AMENDMENT OF SOLICITATION/MODIFICATION OF CONTRACT			1. CONTRACT ID CODE		PAGE OF PAGES	
2. AMENDMENT/MODIFICATION NO. OOO3	3. EFFECTIVE DATE 04/05/02	4. REQUISITION/PURCHASE REQ. N	<u>]</u> 0.	5. PROJECT NO.	1 12_(If applicable)

14. DESCRIPTION OF AMENDMENT/MODIFICATION (Organized by UCF MULTI-YEAR MAINTENANCE DREDOTRIDENT TURNING BASIN, MIDDLE FLORIDA IS AMENDED AS SHOWN O	GING 41-FOOT PROJI TURNING BASIN, AI	ECT, ENTRANCE CH ND WEST TURNING	IANNEL, TRIDE	NT ACCES ERAL HAI	SS CHANNEL, RBOR,	
THE DATE SET FOR BID OPENING IS	EXTENDED TO 18 A	PRIL 2002 AT 2:00 P.	M.			
Except as provided herein, all terms and conditions of the document reference and effect.	d in Item 9A or 10A, as heretofore cha	nged, remains unchanged and in full for	CE			
15A. NAME AND TITLE OF SIGNER (Type or print)		16A. NAME AND TITLE OF CONTRAC	CTING OFFICER (Type or pri	int)	1 1 1 1 1 1 1 1 1 1 1 1 1 1 1 1 1 1 1 1	
15B. CONTRACTOR/OFFEROR	15C. DATE SIGNED	16B. UNITED STATES OF AMERICA			16C. DATE SIGNED	
(Signature of person authorized to sign)		BY(Signate	ure of Contracting Officer)

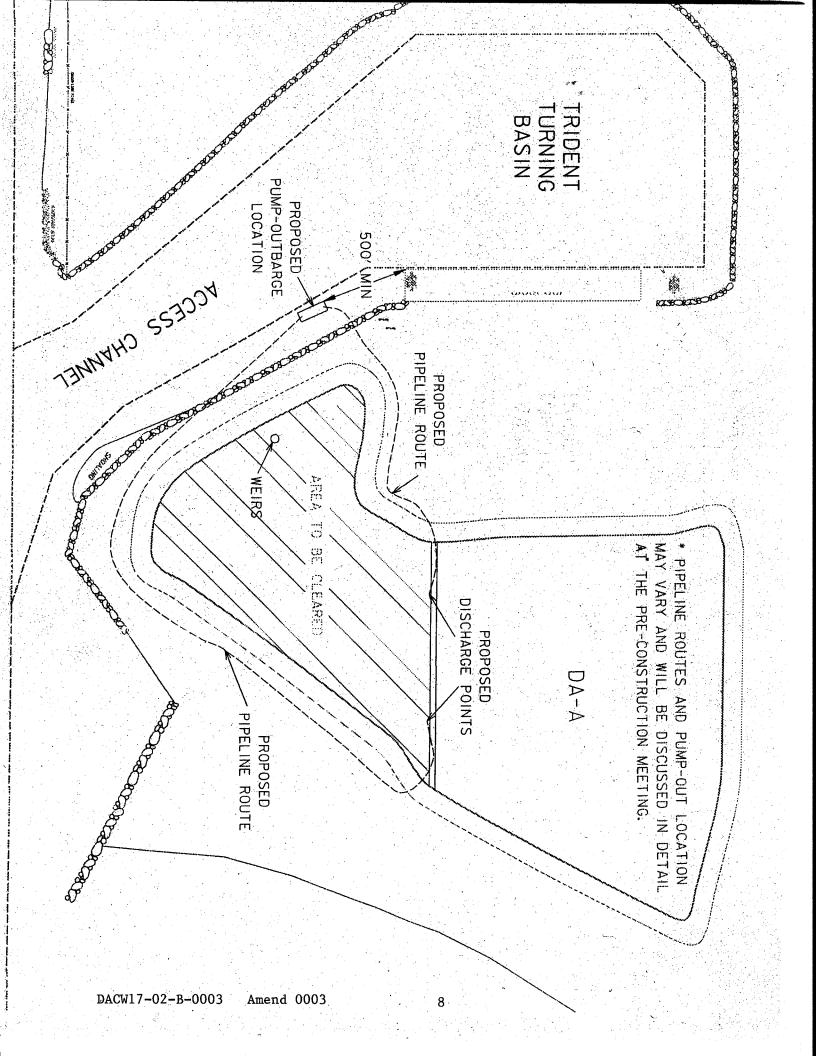
- A: No, necessary clearing will be accomplished by separate contract prior to dredging.
- Q: "If the contractor elects to use offloading equipment for upland disposal, are there any restrictions as to the location of the offloading equipment and operations?

- A: Yes, the offloading equipment will not be adjacent to and west of the submarine wharf. It must be placed south of the wharf and no closer than 500 feet to the wharf. Additionally, see attached drawing for possible pipeline routes.
